FINAL PLAT
THE WATERFRONT SECOND ADDITION
AN ADDITION TO WICHITA, SEDGWICK COUNTY, KANSAS

RE: SUB 2002-128 -- Revised One-Step Final Plat of The Waterfront Second Addition

RE: SUB 2002-128 -- Revised One-Step Final Plat of The Waterfront Second Addition

CASE NUMBER: SUB 2002-128 -- THE WATERFRONT SECOND ADDITION

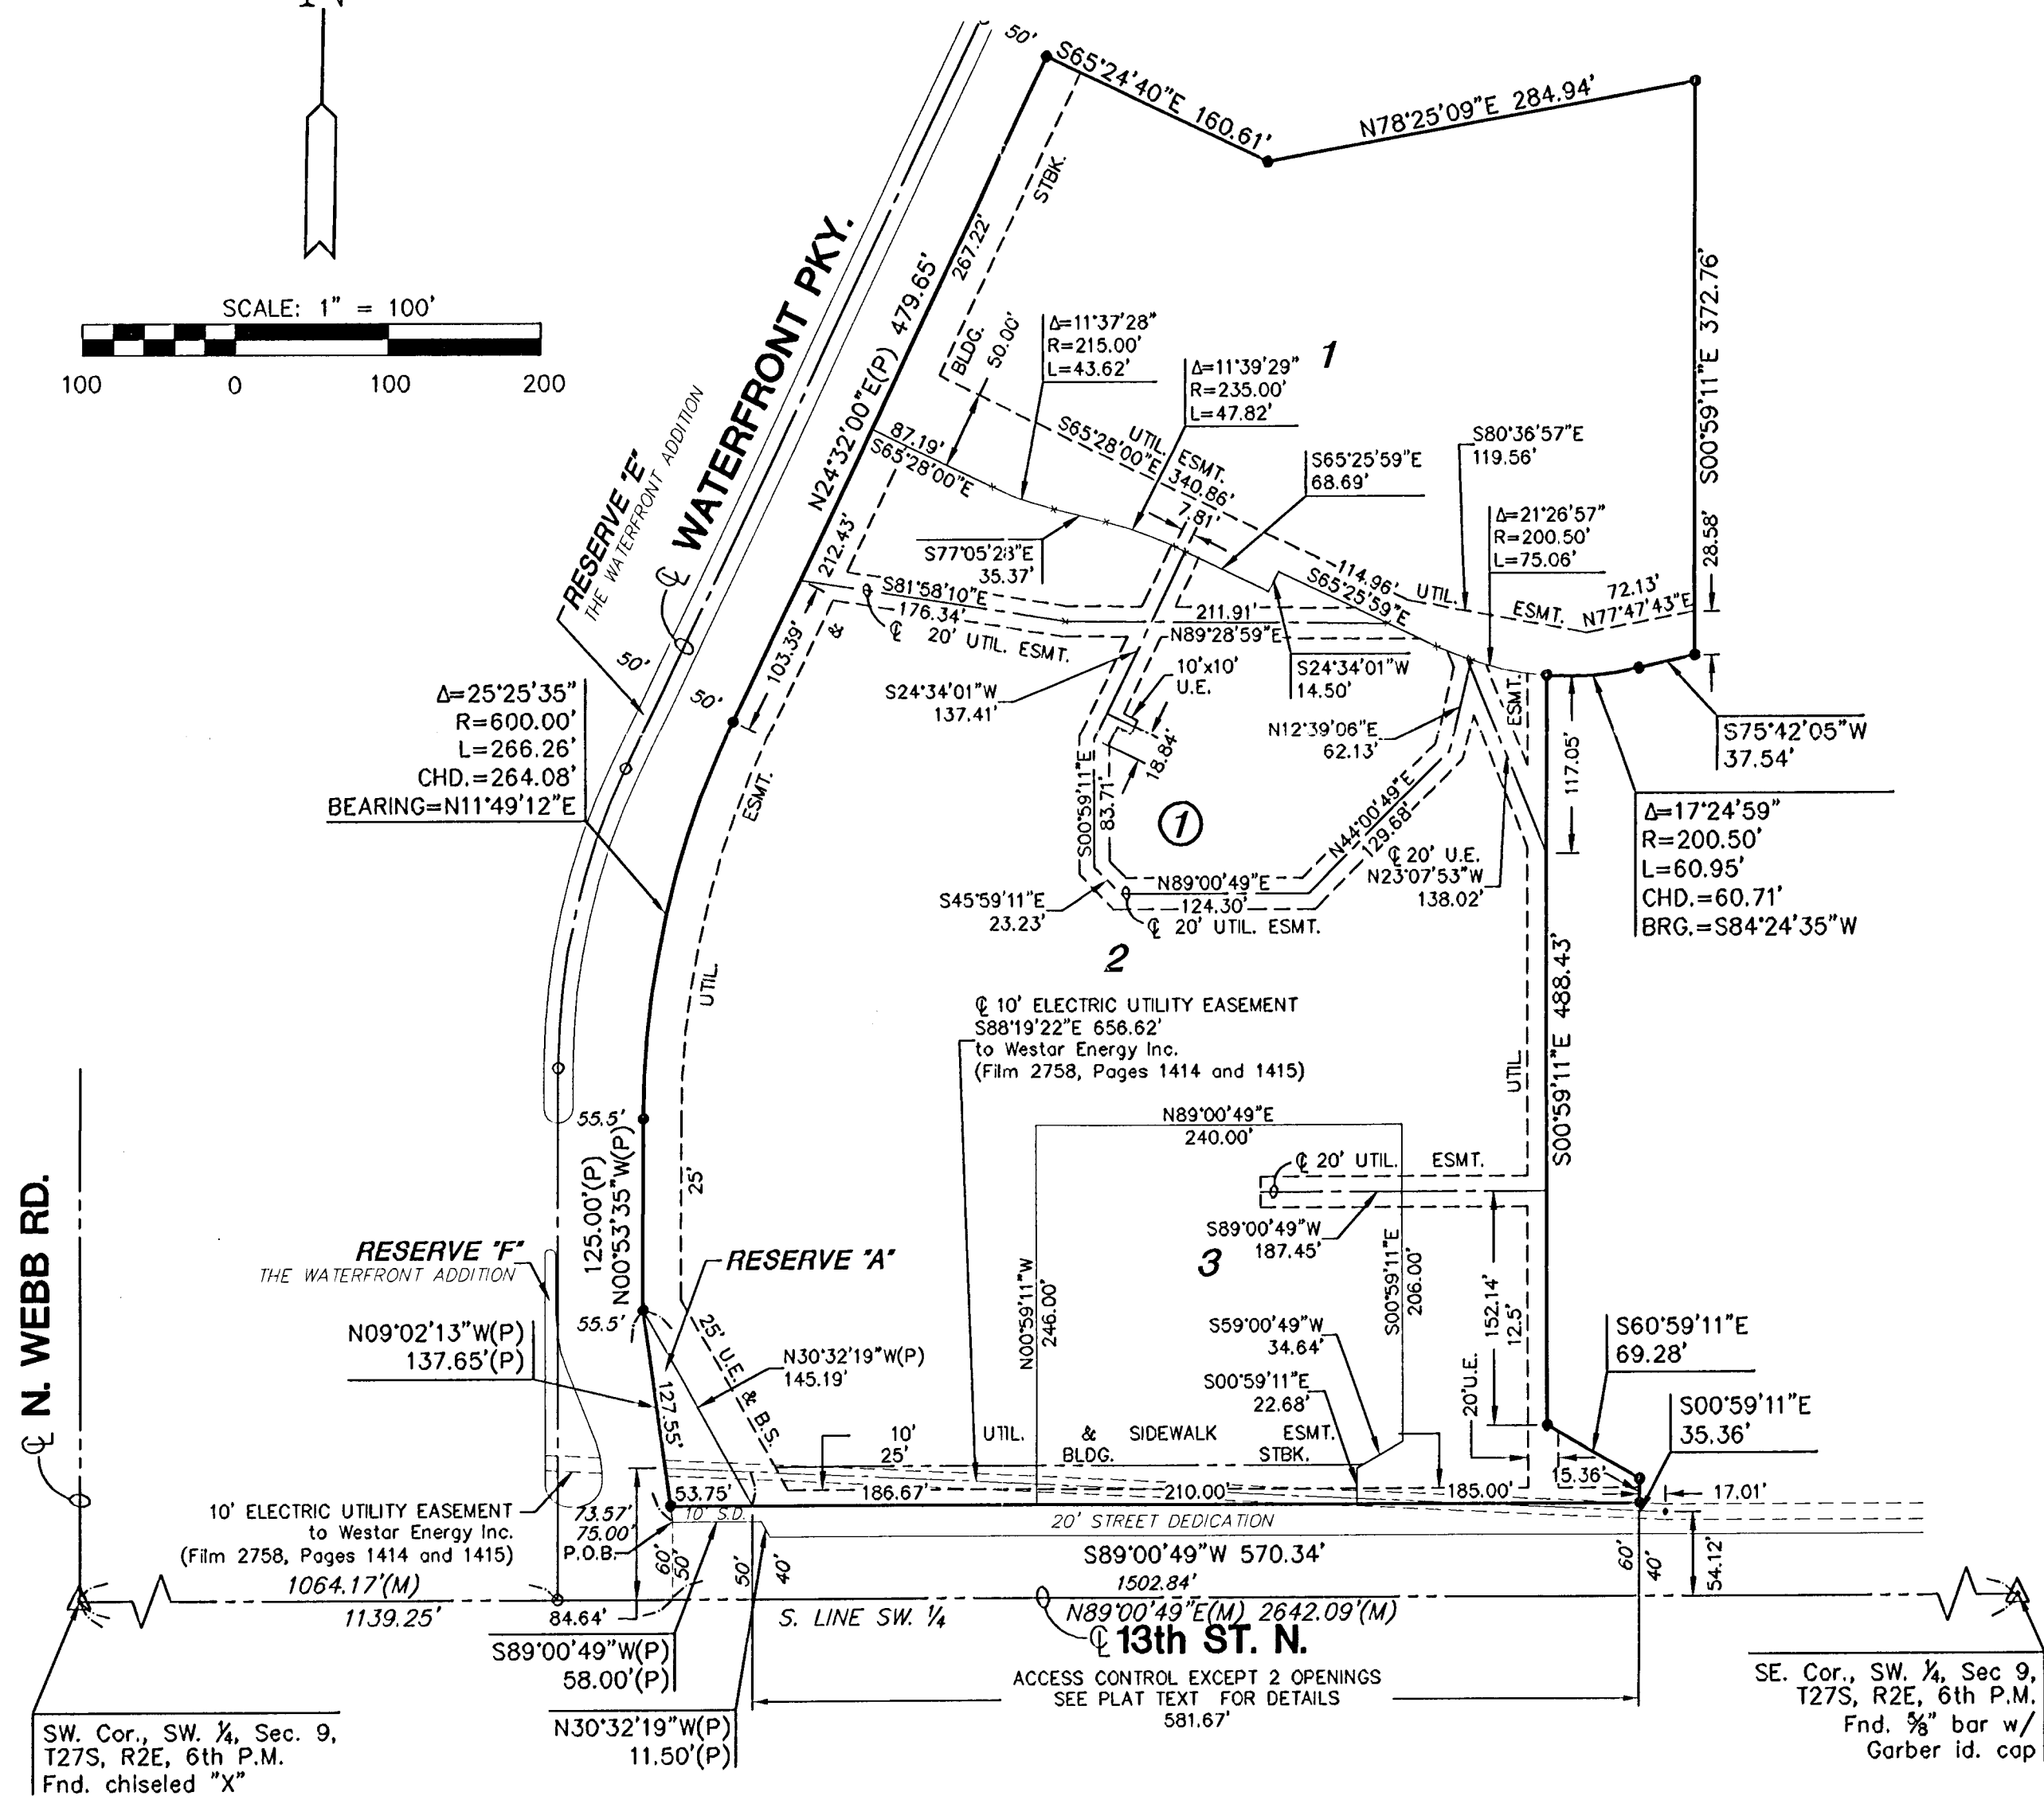
- C. **City Engineering** needs to comment on the status of the applicant's drainage plan. *The drainage plan is approved.*
- D. The plat proposes two access openings along 13th Street in accordance with minimum spacing standards of the access management regulations.

- E. "13th St N" shall be correctly denoted on the plat.
- F. **Traffic Engineering** has requested a petition for a left turn lane into the full movement drive.

- G. **County Surveying** advises that the 30-ft utility easement needs located.
- H. The applicant shall submit an avigational easement covering all of the subject plat and a restrictive covenant assuring that adequate construction methods will be used to minimize the effects of noise pollution in the habitable structures constructed on subject property.

- J. The signature line for the City Clerk needs to be revised to reference "Karen Schofield".
- K. The MAPC signature block needs to reference "Ronald L. Marnell, Chair".
